**A&M Project #:** 1179-20A  
**Re:** Response to Comments  
55 Industrial Park Road  
Notice of Intent

On behalf of our client, Saxon Partners, Allen & Major Associates, Inc. (A&M) is providing the following responses to an email dated 12/03/2024 from the Conservation Officer. These comments also reflect comments received by MassDEP as part of the completeness review and issuance of a project file number. Changes to these drawings may be found through the attached Revision 2 of the Site Development Drawings as dated December 23, 2024. These drawings also reflect changes made as a result of the engineering peer review conducted by PGB Engineering, Inc. in a letter dated December 5, 2024. The response to the individual comments to PGB are contained within a separate letter as dated December 23, 2024 to the Hingham Planning Board by A&M. Also, attached hereto is the NOI Supplemental dated November 12, 2024. This information was issued electronically to MassDEP as part of their initial review. The responses contained within also address the initial comments received by the Conservation Officer below.

**A&M Project #:** 1179-20A  
**Re:** Response to Comments  
55 Industrial Park Roa

**RIVERFRONT ASSESSMENT**

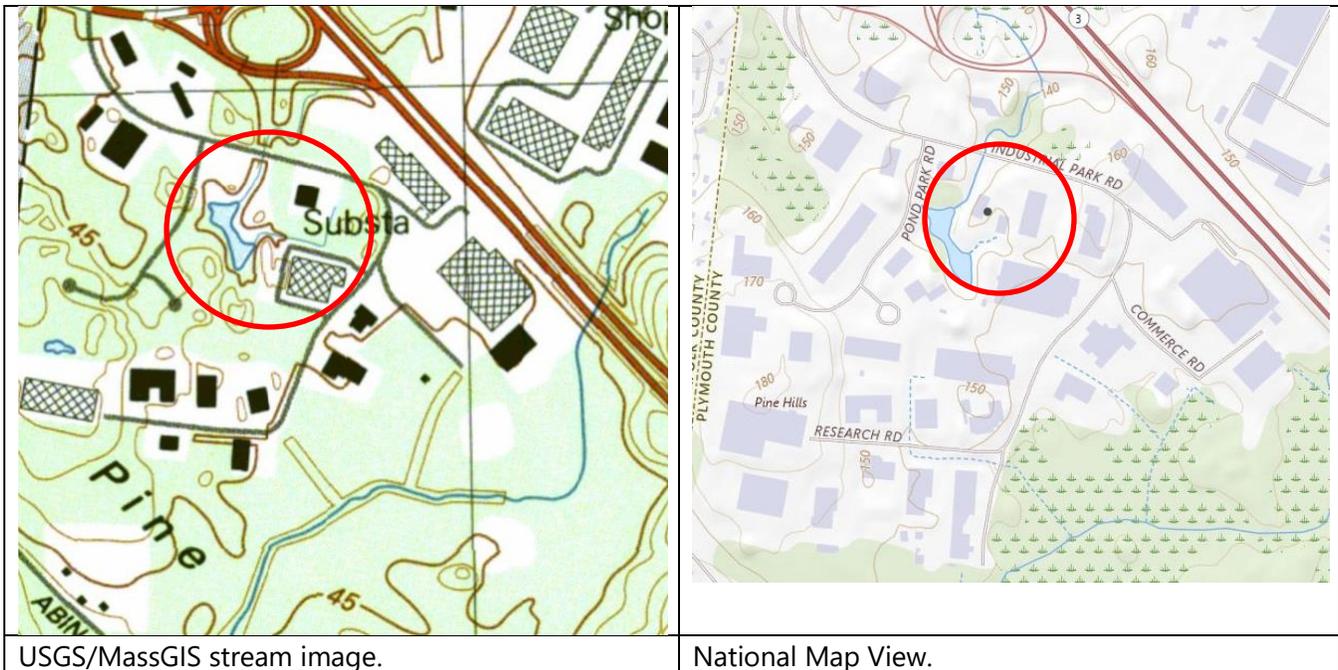
- Was the stream assessed per 310 CMR 10.58(2)(a)1.d. to determine an intermittent status? If so, please provide documentation.
    - Please be advised that the Boston Harbor Basin has been in a declared drought since September 1, 2024, and that any field observations made after this date are not admissible to find a stream to be intermittent.

- If determined to be perennial, please provide a calculation of Riverfront Area impacts on the WPA Form 3 (Item B.2.f, Page 3) and any associated materials required for the performance standards under 310 CMR 10.58.

As reported by Mr. Brad Holmes, the assessment on the intermittent stream classification was rendered through review of the USGS online viewer where the waterway shows as a 'light blue' line indicative of an intermittent classification. The stream does not shown on the Massachusetts Streamstats Program website. The summary report was prepared on May 8, 2024. Just after preparation of the report, the Department has implemented a newer policy to rely on the National Map Viewer USGS site for classification of streams. The stream is depicted in 'dark blue' which would be perennial for permitting purposes. A comparison of the imagery is shown below.

Given the presence of a perennial stream meeting the classification standards of the Wetlands Protection Act, review against the performance standards of 310 CMR 10.58 are required. Riverfront Area: As defined at 310 CMR 10.58(a)(3), *Riverfront Area is the area of land between a river's mean annual high-water line measured horizontally outward from the river and a parallel line located 200 feet away.*

DRAWING TITLE:	SHEET No.
EXISTING DEGRADED AREAS	SK-1

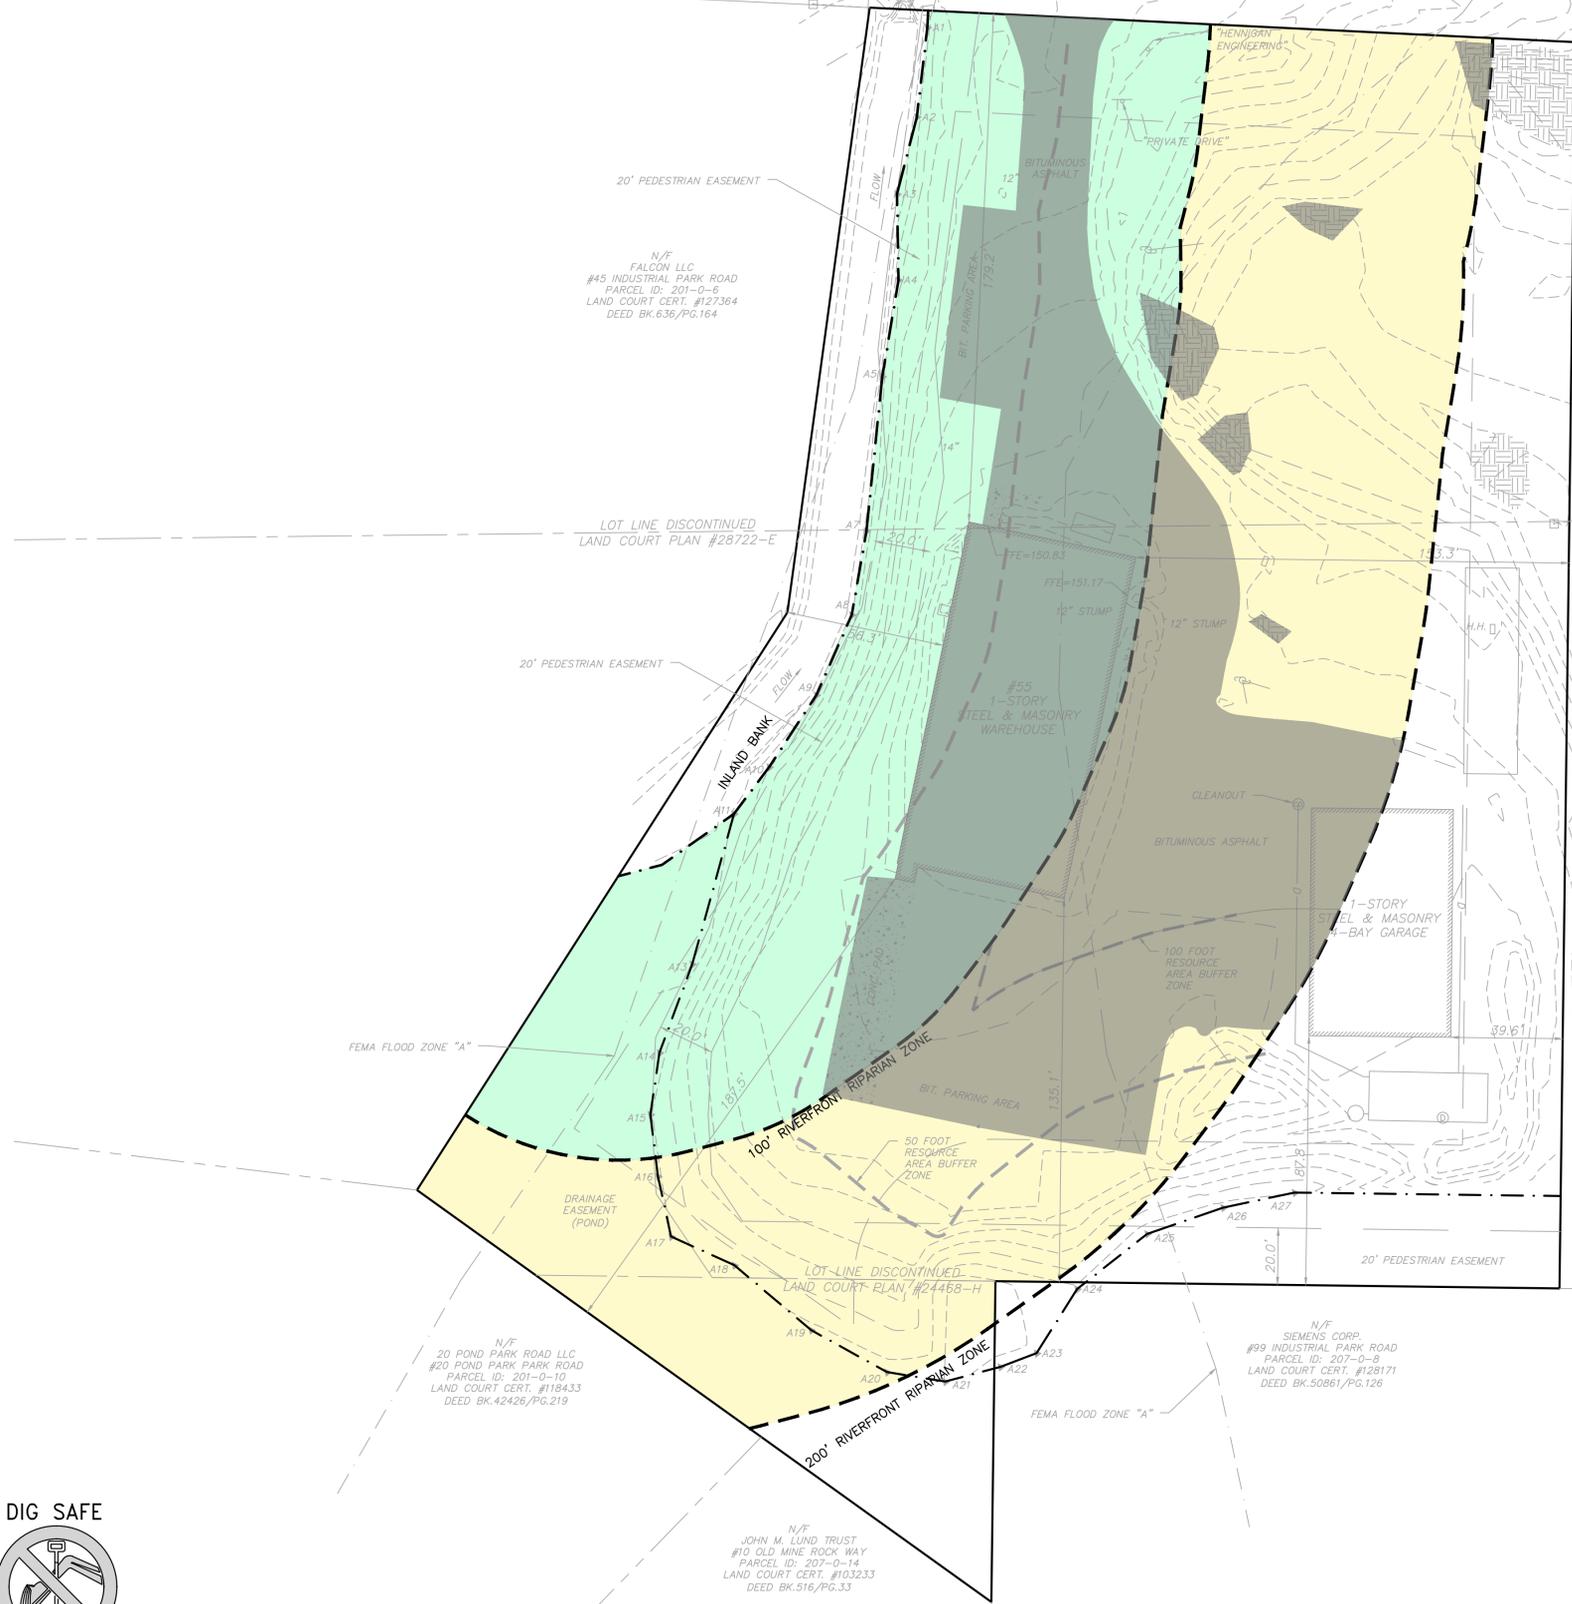
*Comment 8:* The proposal includes alterations (which may be pervious or impervious) within the Buffer Zone therefore compliance with the Commission's Buffer Zone Mitigation Policy is required. Please provide a summary table on the plan or in the narrative documenting existing and proposed conditions in the 0-50 and 50-100' foot Buffer Zone so staff may determine if mitigation is required.

**Response 8:** The requested alteration summary is provided on the attached SK-1 and SK-2 figures.

Riverfront Area	Area onsite (s.f.)	Area disturbed (s.f.)	% of onsite area affected	Area degraded/ impervious (s.f.)	% of onsite area affected	Total % of Riverfront modified from its natural state
0 - 100	44,894	4,010	8.93	18,670	41.6	50.5
100 - 200	59,021	5,916	10.0	19,841	33.6	43.6

Plan 634 of 1975

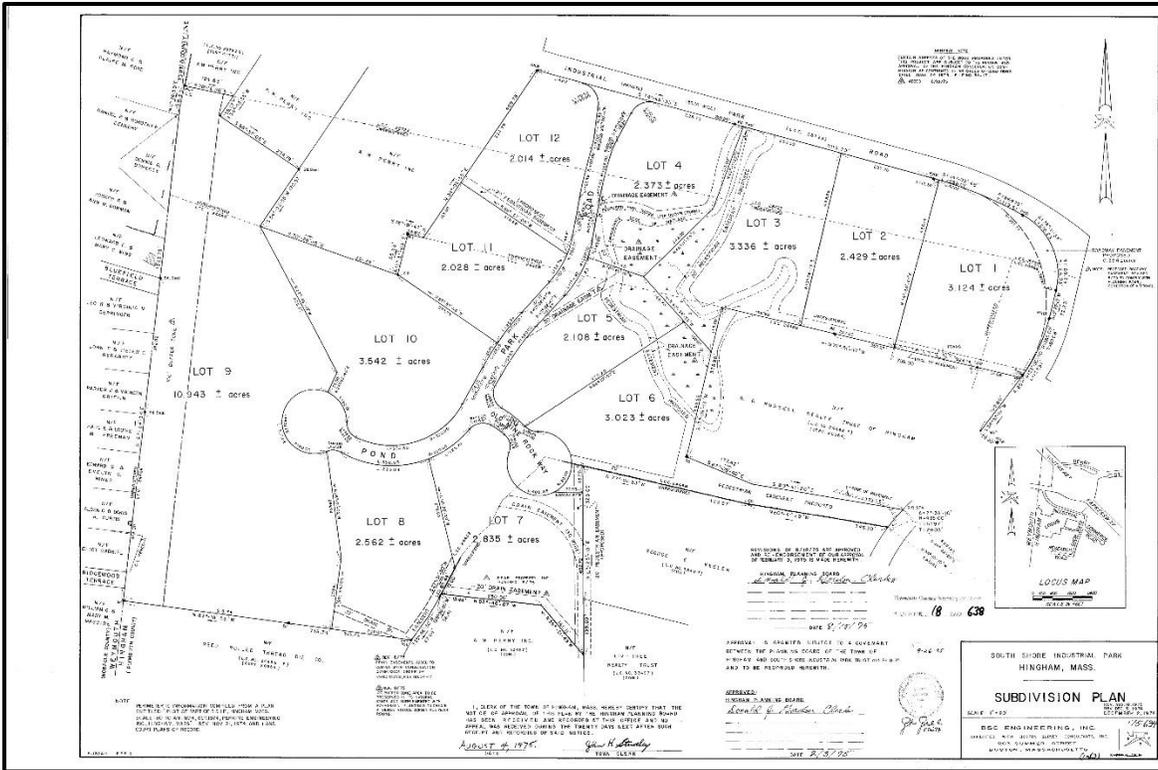
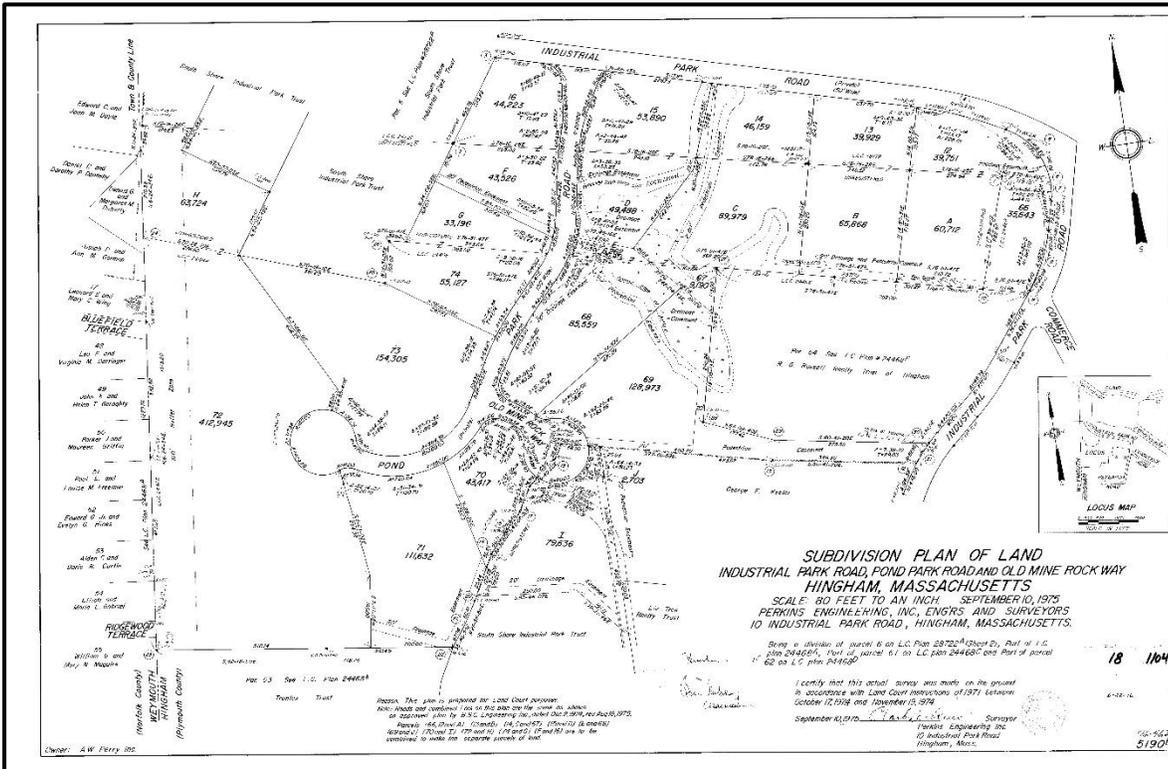
*Comment 2: What is the 20' pedestrian easement? Please provide recording information for this.*

**Response 2: The 20' pedestrian easement is shown as taken from the record subdivision plan prepared by BSC Engineering, inc. as dated December 2, 1974 and revised through August 18, 1975 and recorded in the Registry as Plan 634 of 1975. It is unclear the original intent of the easement and who maintains rights within the easement. Similarly, there is no record of the easement having been extinguished. It also appears again on Plan 462 of 1976 prepared by Perkins Engineering, Inc. as dated September 10, 1975.**
